# Agenda Item #1

# Application 2024-17-CA

54 N. Cedar Street

Relocate historic structure to 265 N. Dearborn Street

### Relocation Guidelines: Building placement of the relocated building

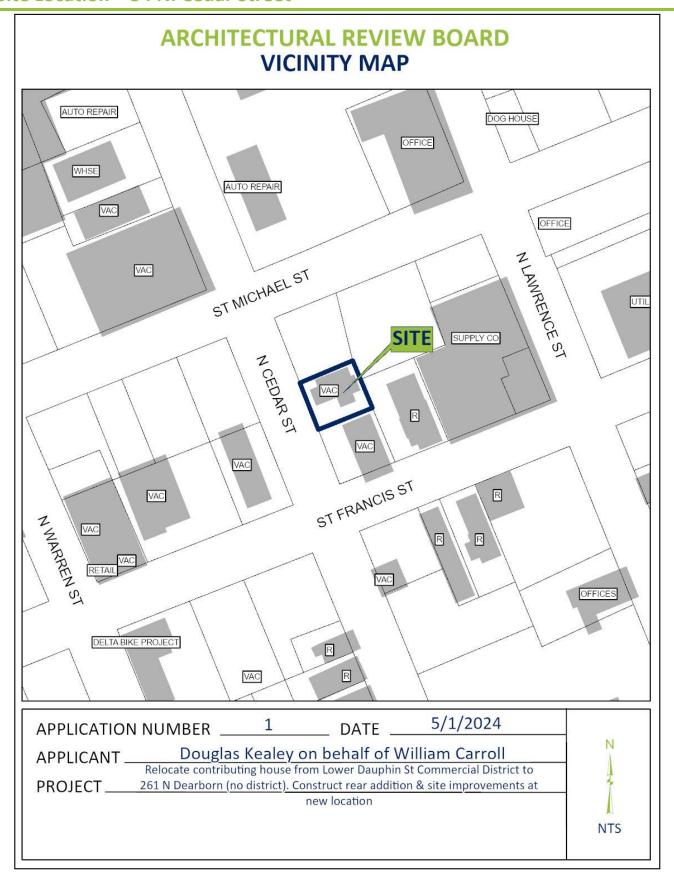
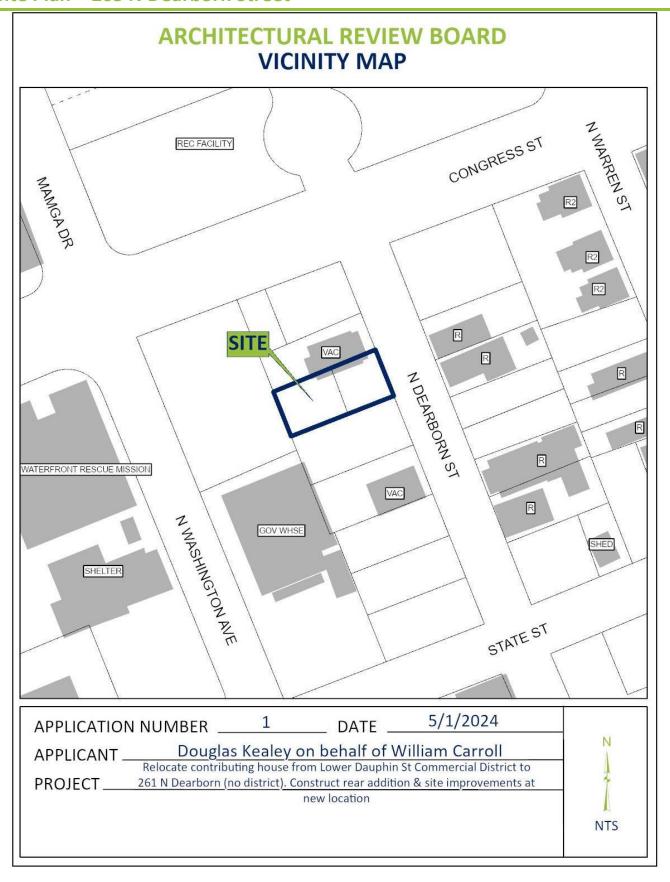
The proposed new placement for the subject building would reflect its current placement and orientation on N. Cedar street. A proposed front setback of 16'-0" sits within the proposed setback range that will be established with the mix of existing historic properties and planned new construction. Likewise, the lot on N. Dearborn street is of a similar width but is significantly deeper. However, it is of an appropriate depth to accommodate the proposed additions for the rear of the original structure and would appear of a comparable size from the street, as directed in the *Guidelines*.

All repairs proposed for the structure are in-kind replacements which are in conformance with the *Guidelines*. The application also proposes the installation of a new two-over-two wood sash window to fit the existing opening. This replacement would not impair the established fenestration pattern on the elevation. (5.6-5.17, 6.5-6.8)

The *Guidelines* call for an addition to an existing historic structure to be subordinate to and compatible with the main structure in placement, massing, scale, and rhythm. This application achieves these objectives with the placement of the one-story addition to the rear of the property, which does not disrupt the existing massing and scale of the property. The footprint of the addition would increase the original structure's square footage to 1514, which is almost double its original footprint of approximately 800 sf. The roof design proposed for the addition would be appropriately incorporated to the existing roof design, and the change would be minimally visible from the street. Foundation and ceiling heights proposed for the addition match those of the existing house. (6.9 - 6.11, 6.14, 6.15, 6.19)

All exterior materials intended for the addition match the original historic structure and are of appropriate design, to include the wood siding, wood windows, and trim, along with matching masonry foundation piers and lattice infill panels. (6.13, 6.19, 6.21)

Site improvements proposed for 265 N. Dearborn include a brick walkway linking the front steps to the sidewalk, and a concrete driveway located to the north of the house. Both the walkway and driveway would be created in accordance with the *Guidelines*. (10.2, 10.5, 10.7)
